Mountmellick Flood Relief Scheme An Coimisiún Pleanála Submission Response Note Case # ACP-323830-25

February 2026

This report relates to the Mountmellick Flood Relief Scheme commissioned by Laois County Council (LCC), on behalf of the Office of Public Works (OPW).

Figure 2.1: Scheme Study Area and Property R32X8Y2

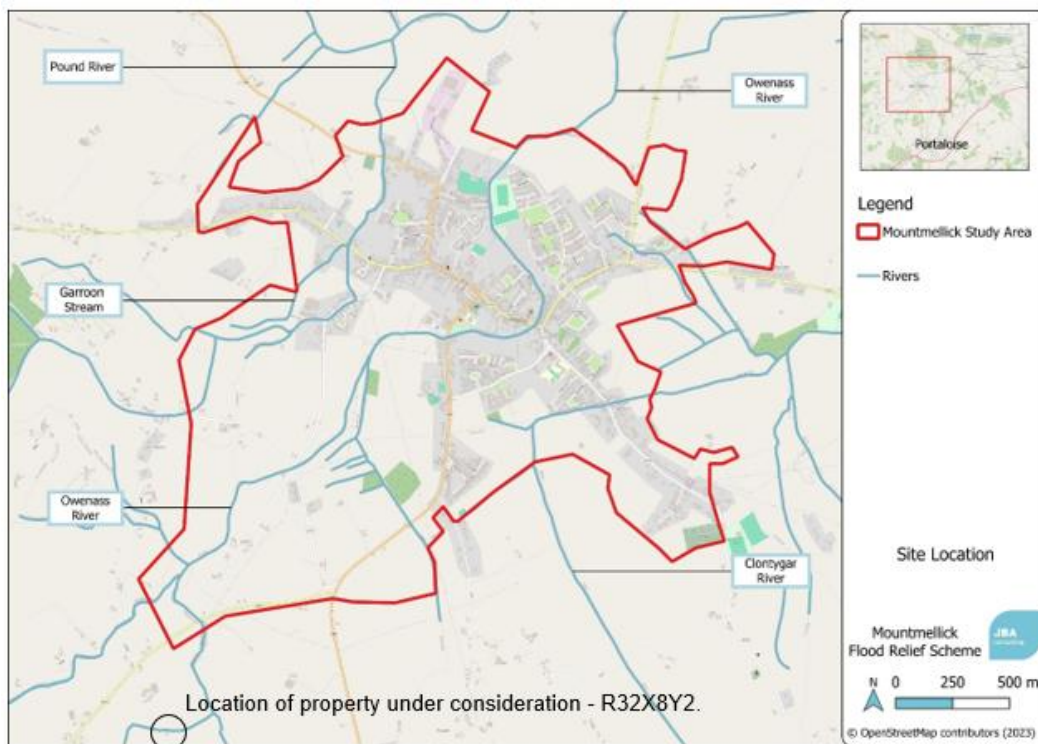
They also expressed concern about the impact of the proposed scheme on flood risk at their property as they were shown the flood maps resulting from the scheme that show areas where flood water will back up and move into flood storage areas. They also expressed concern regarding the drainage networks installed by local farmers and the removal of trees in the Slieve Bloom mountains – both of which they feel will increase the volume of water flowing in the stream adjacent to their property and in the general area.

Figure 2.1. below shows the location of the property being considered and confirms that it is located outside the scheme area.

We also reviewed the hydraulic model to see if the proposed FRS would have any impact on the flood levels at the property for the 1% AEP event. The results of the modelling review are given in Table 2-1 below.

Figure 2.3: Surface Water Drainage in Davitt Road Area

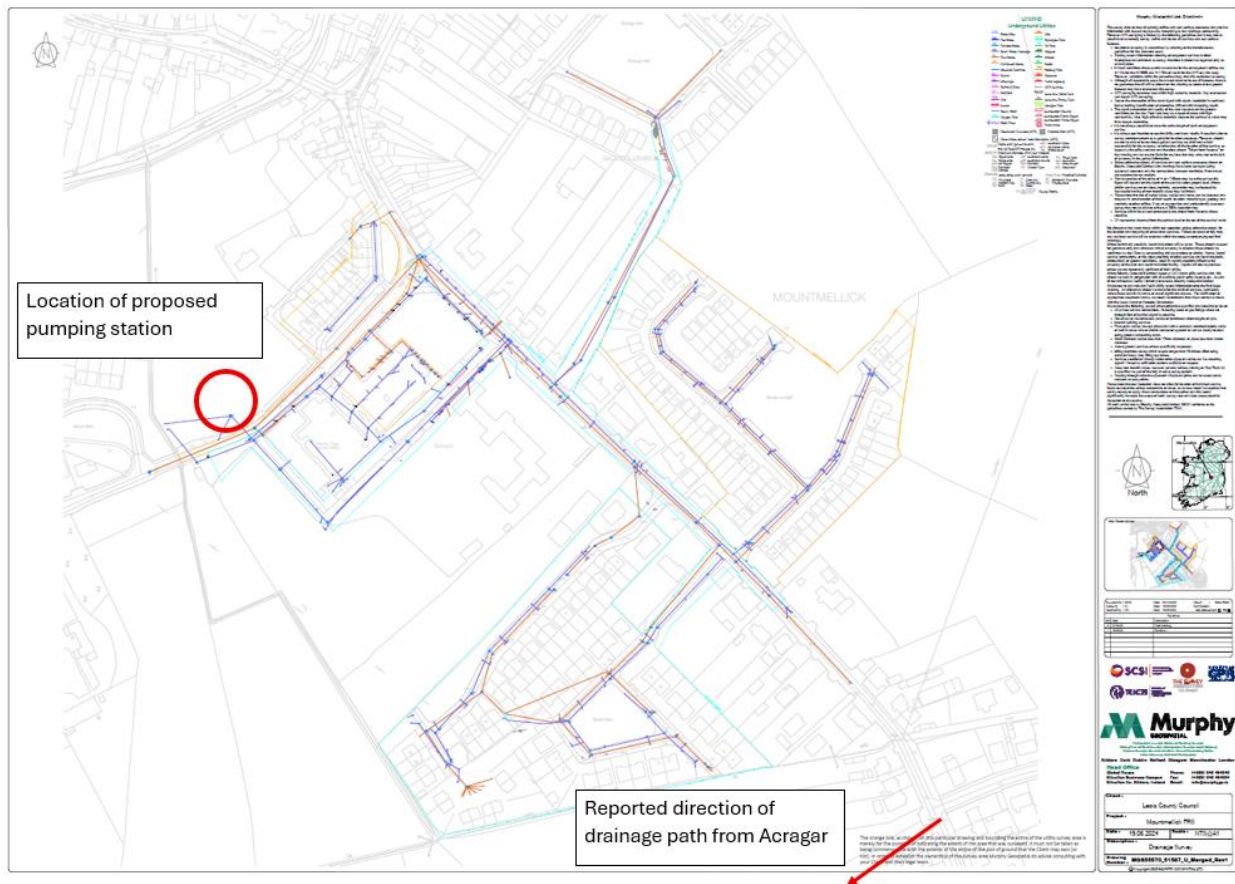
Darrin Dunne commented they object to the planning of the Mountmellick FRS as the works that were proposed 'does not benefit the Mountmellick Flood Relief Scheme because the surface/storm water off Davitt Road and Acragar Road no longer come down. There is a new pipeline installed and goes to the Islands in Mountmellick on opposite side of the road 6 years ago. The drain has been full for the past 20 years with waste and rubbish and not maintained and no benefit to the adjoining properties – 2.3m higher than my field and my field has never flooded so I can't understand how the properties have flooded.'

Mr Dunne is correct that the surface water drainage system from the Acragar area does not flow along Davitt Road but has been diverted to flow southwards – as shown by the red arrow on Figure 2-3 below.

However, beyond the junction between Davitt Road and Acragar in the direction of the town, Figure 2-3 shows the extent of the surface water drainage system that flows in a northwest direction. This system has been surveyed (topographic and CCTV) to confirm its alignment, condition and direction of flow along Davitt Road and outfalling at the location of the proposed pumping station. It is this drainage network which has been modelled to ensure that the proposed scheme does not impact on the surface water drainage system in the Davitt Road area.

Figure 2.4: 1% AEP Event with FRS in Place

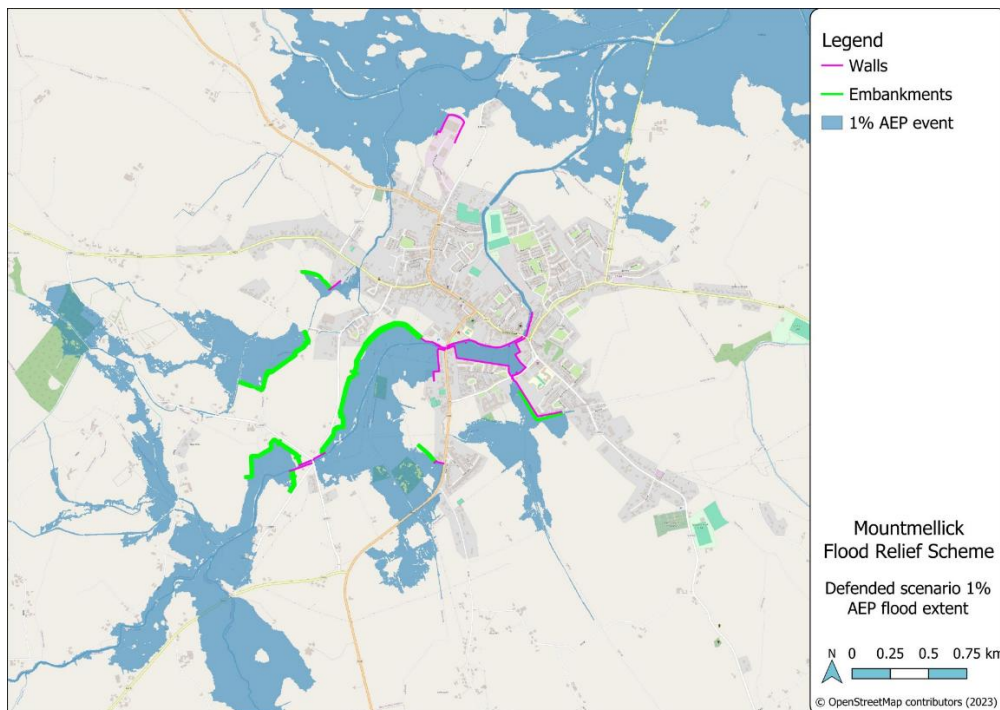
- a. 1%AEP HEFS to 2100, and
 - b. 0.1%AEP baseline, including appropriate climate allowances.
3. If the modelling confirms that the proposed FRS increases flood risk to the high bank properties or to their wells and septic tanks, require the design to be modified to incorporate reasonable mitigation measures, such as:

- 1a. The latest agreed model for Derrycloney has been used in the development of the flood outline and planning design. Figure 2-3 in the AA and Figure 3-4 in the NIS (these are the same figures) show a slightly different profile in the field opposite the Derrycloney Residents. The revised figure is shown below in Figure 2-4.

Figure 2.6: Flood Extents with 1% AEP Scheme in Place for 1% AEP Present-Day, MRFS and HEFS Flood Events

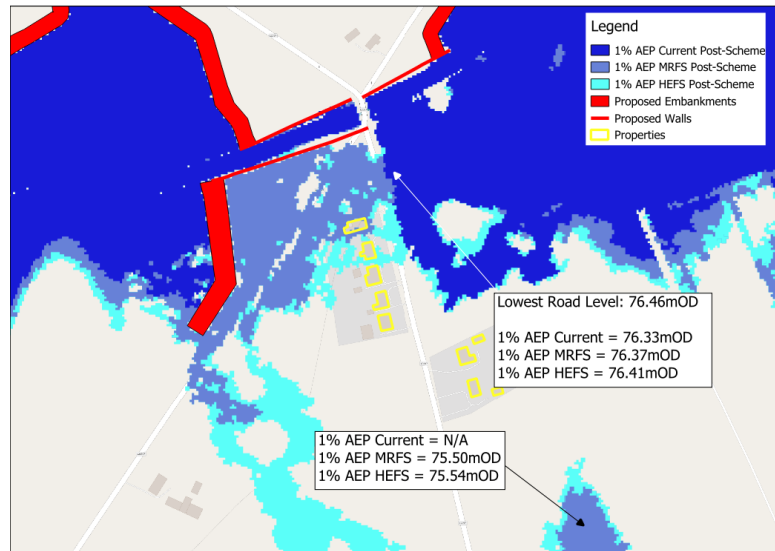
- 2a. The residents ask for assurance that the FRS will not increase flood levels at their properties as a result of at least a 1% AEP HEFS to 2100. At present, the guidance on a the HEFS is that it will result in a 30% increase in the present-day flows. This is what has been modelled and the output given in Figures 2-6 and 2-7.

We have considered the impact of the proposed 1% AEP present-day scheme on the properties for the present-day 1% AEP flood event and, to allow us to assess the impact of climate change, the 1% AEP MRFS and HEFS. The results of the modelling are shown in Figure 2-6. It can be seen that the present-day scheme will protect all the properties from the 1% AEP present-day event. When the impact of climate change is applied to the flows, the flood water does flow around the proposed present-day scheme and enters the area of the properties. It should however be noted that these climate change flood extents will only occur if the climate change adaptation measures are not implemented as planned in the future. The long-term integrity of the scheme depends on the climate change adaptation being implemented.

Although the flood extent for the 1% AEP event does move closer to the properties with the scheme in place, it only extends across the field to the east of the properties. The 1% AEP present-day scheme with 1% AEP present-day flow does not result in the inundations of the properties or their gardens. There would be inundation at some point in the future if flows increase as a result of the impact of climate change. We have used the MRFS and HEFS to develop suitable climate change adaptations measures for the scheme which, when implemented, would continue to protect the Derrycloney residents and their gardens into the future. It should be noted that the climate change adaptation measures modelled represent one option for adaptation and that in the future any decision made regarding adaptation will be made in the context of future laws and norms.

Figure 2.8: Flood Extents with Scheme (as submitted) in Place for 0.1% AEP Present-Day Flood Event

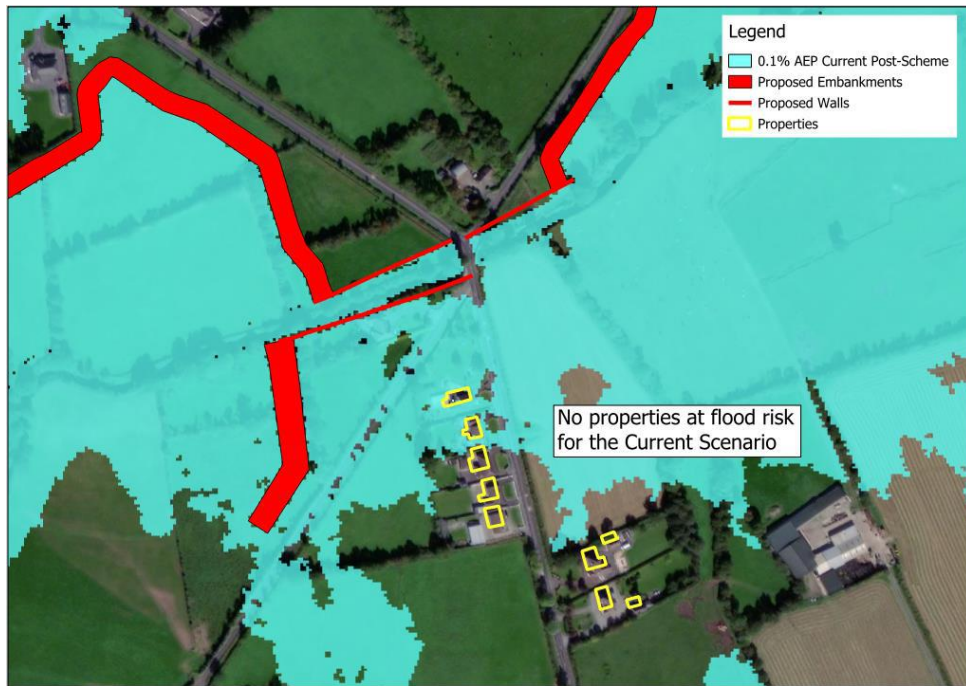
- 2b. The residents ask for assurance that the FRS will not increase flood levels at their properties as a result of at least a 0.1% AEP, including appropriate climate change allowances. We would say that we do not think it is appropriate to apply climate change allowances to such an extreme flood event as the flood scheme will be subject to adaptation and so the present-day scheme will never be subjected to the 0.1% AEP at a point where climate change flows are the norm.

We have looked at the impact of the 1% AEP present-day scheme on flood extents if it were subjected to the 0.1% AEP extreme flood event. The results of the modelling are shown in Figure 2-8. We also include the comparison between property floor levels and flood levels resulting from the 0.1% AEP event in Table 2-2.

Figure 2.9: Flood Extents with 1% AEP Defended and Undefended

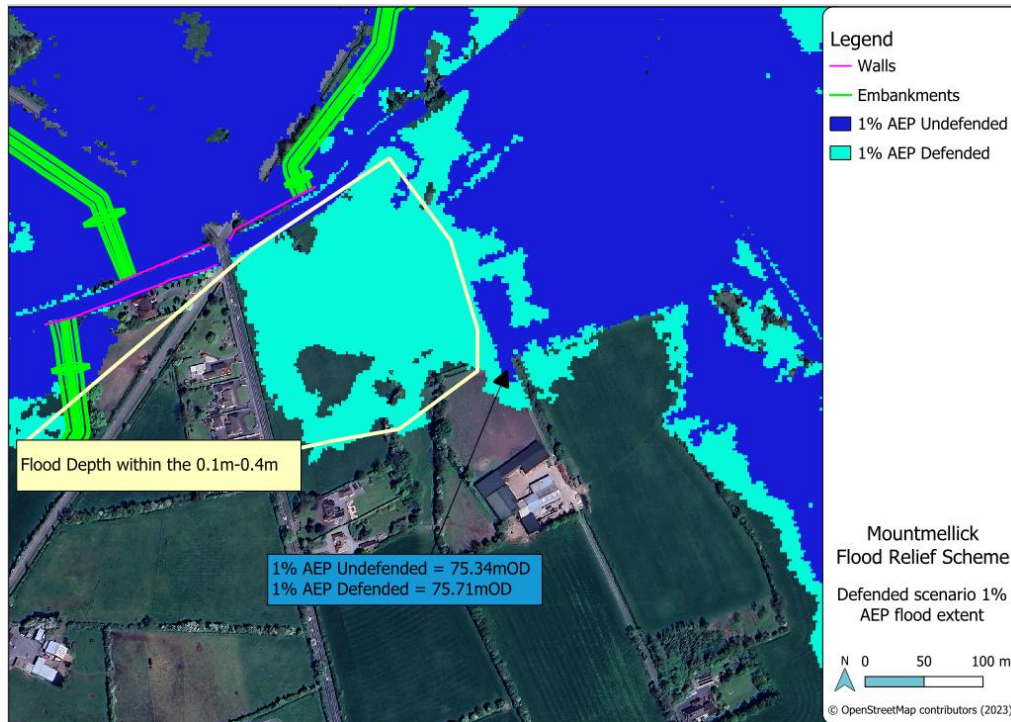
He confirmed that he has not been given any details of how long his land would remain flooded and needs this to provide clarity on how long his land would be inaccessible.

The proposed scheme will mean that part of his land will be inundated as a result of a 1% AEP event, but his farmyard will remain outside the resulting flood extent and so there should be no risk to his slurry storage facility.

His land is at the extremity of the floodplain and so the depth will be minimal at the duration of inundation will also be minimal. It should be noted that the scheme does not increase flood risk in this area for the lesser events of the 50% AEP, 20% AEP and 10% AEP.

We have looked at the flood hydrographs at various locations in the 1% AEP defended condition and it shows the duration of the flooding in the field area varies between 4 hours and 12 hours with an average of approximately 8 hours.
